Index 550-012 Bridge Fencing (Enclosed)

Proposed Revisions to a Standard Plans Index
(Please provide all information — Incomplete forms will be returned)

Index Number: 550-012
Sheet Number (s): 1 and 4 of 4
Index Title: BRIDGE FENCING (ENCLOSED)

LAST REVISION 11/01/23	DESCRIPTION:	 FY 2024-25 STANDARD PLANS	BRIDGE FENCING (ENCLOSED)	INDEX 550-012	SHEET 1 of 4
---------------------------	--------------	---	----------------------------------	-------------------------	------------------------

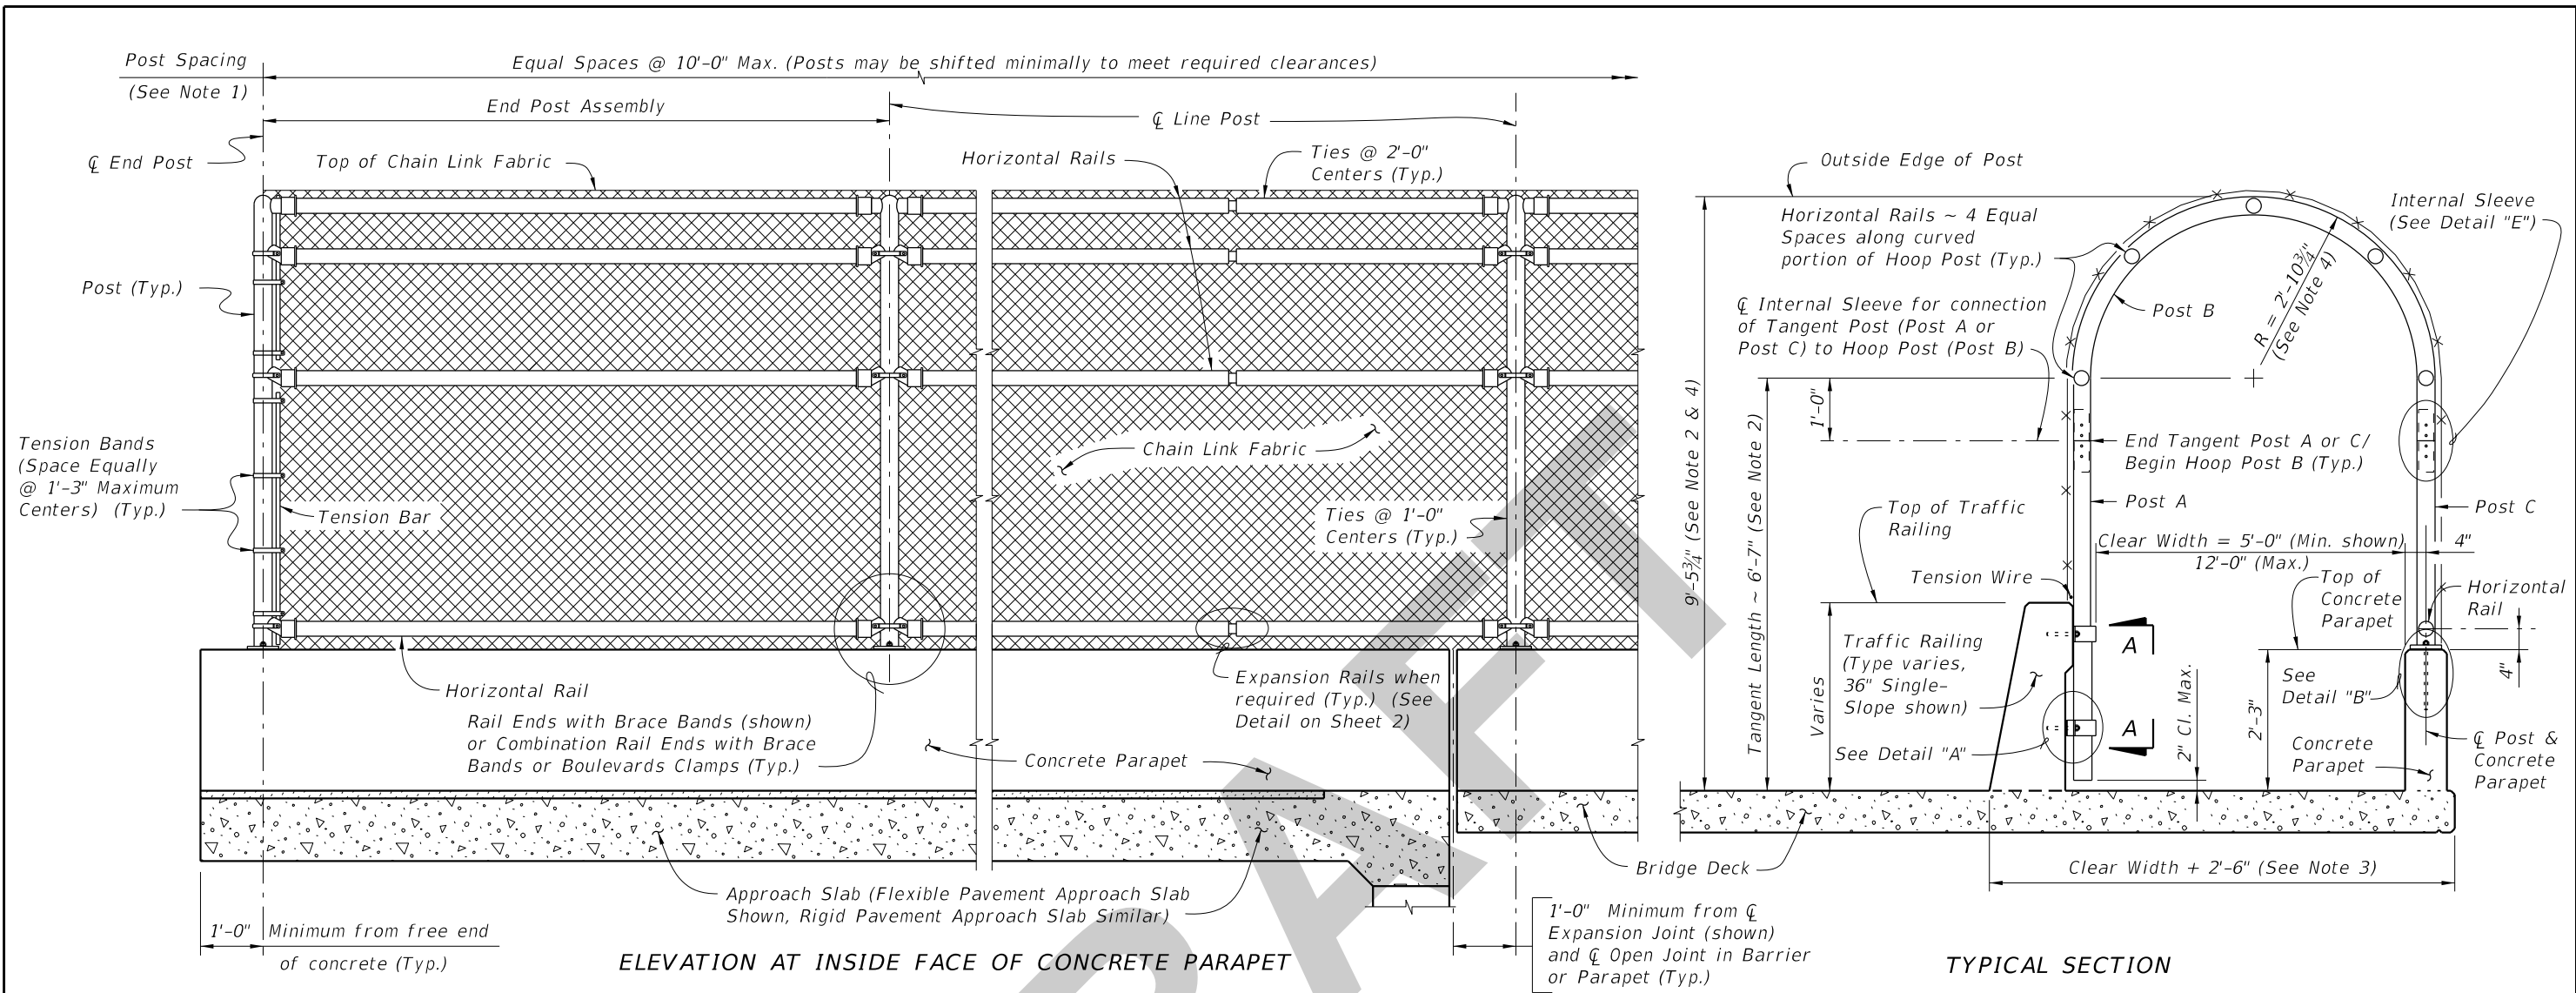
COMMENT: The design office understands the potential need to have a maximum width, but we propose that if that maximum width is 12 feet, that the term "pathway" not be used. We propose that "sidewalk" remain given this width would create a sidewalk condition.

Sheet 1: Removed the 7'-5" dimension because the calculated dimension is off by 3/8" and the dimension varies depending on clear width; Changed the 5'-5" dimension to varies because it varies; Revised the Clear Width note from 5ft min to add 12 ft max.

RESPONSE: Based on this comment and the corresponding discussions, the reference to "pathway" will revert to "sidewalk".
